CERTIFICATE OF APPROPRIATENESS

Property: 1122 Arlington Street, Lot 18, Block 197, Houston Heights Subdivision. The property includes a historic 1,213 square foot one-story, wood frame single-family residence and one-story brick detached garage situated on a 6,600 square foot (50' x 132') interior lot.

Proposal: New Construction – Construct a new detached two-story alley-loading garage at the rear of the property.

WEST ELEVATION – FRONT FACING ARLINGTON STREET
PROPOSED (WITH RESIDENCE)

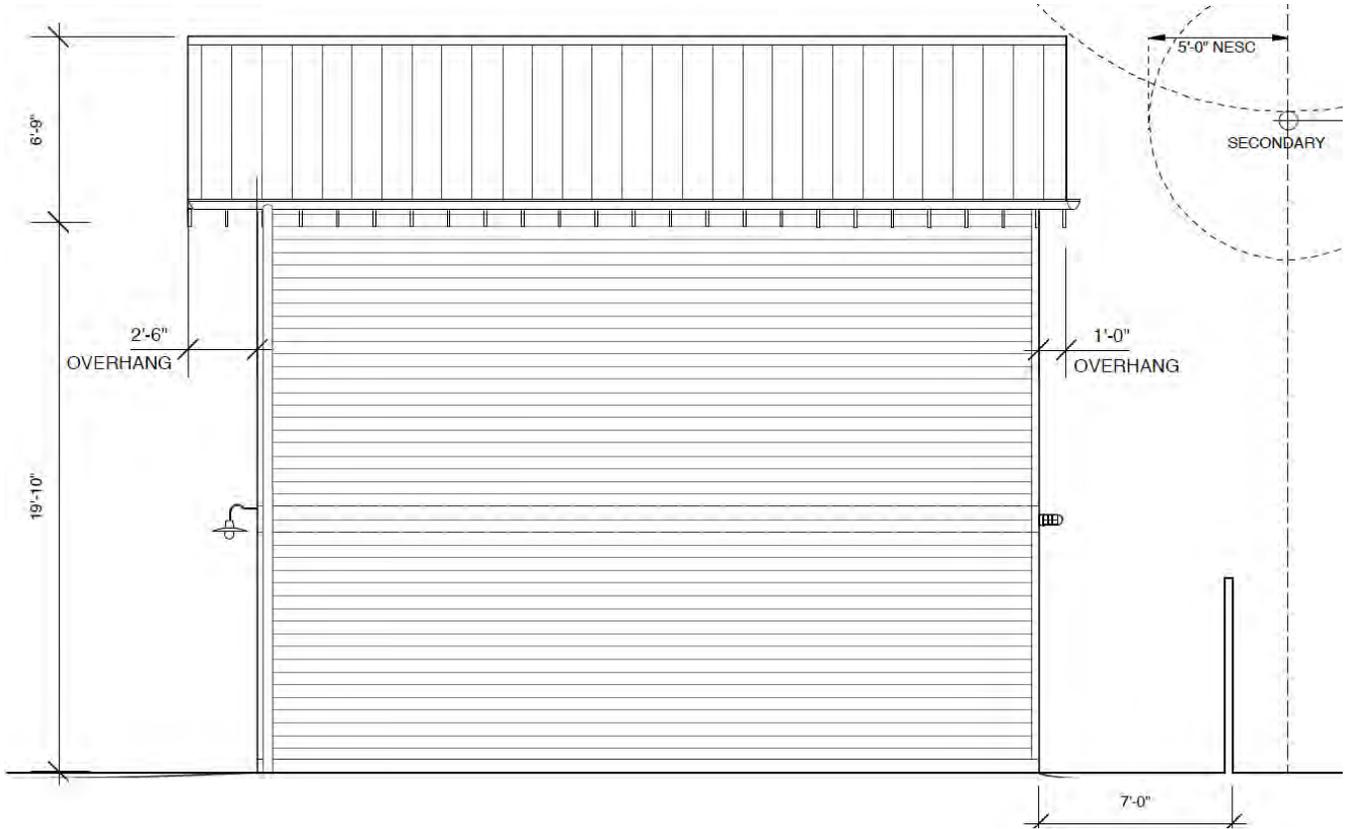
1122 Arlington – Question use of square windows on street side elevation. Sets up view conflict with existing house. Large volume of proposed 2 story is out of context with the smaller one story existing house. Note 7'-1" garage setback along alley should be verified. 9' is usually required to exit and enter garage on alley.

1122 Arlington — No Objection — Some concerns with garage towering over house

SITE PLAN

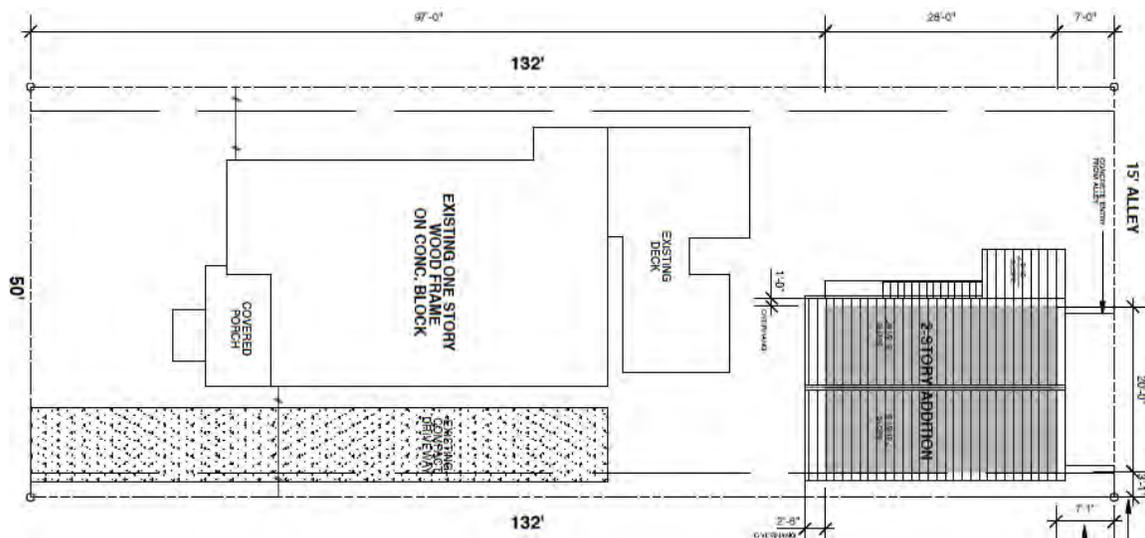
The distance issue is fine, what I need to know more about is the condition of the alley at this home. Is the alley paved all the way to the lot or do you need to provide plans to construct the alley from its current end to the far side of the driveway.

Alley is not paved. They can not afford this themselves and there hopes is getting the neighbors on board to help pay for this in the coming years. They will park on the existing drive from Arlington as they currently do.

Richard Smith is aware of this and is ok with the garage door facing an unpaved Alley. I have Cc:d Mr.

Setbacks: The proposed garage will have a front (west) setback of 97'-0", a south side setback of 3'-1", a north side setback of 26'-11"; and a rear (east) setback of 7'-1". Although a 9'-0" setback would be more typical for an alley loading garage, Public Works does not have an issues with the proposed reduced setback. See drawings for more detail.
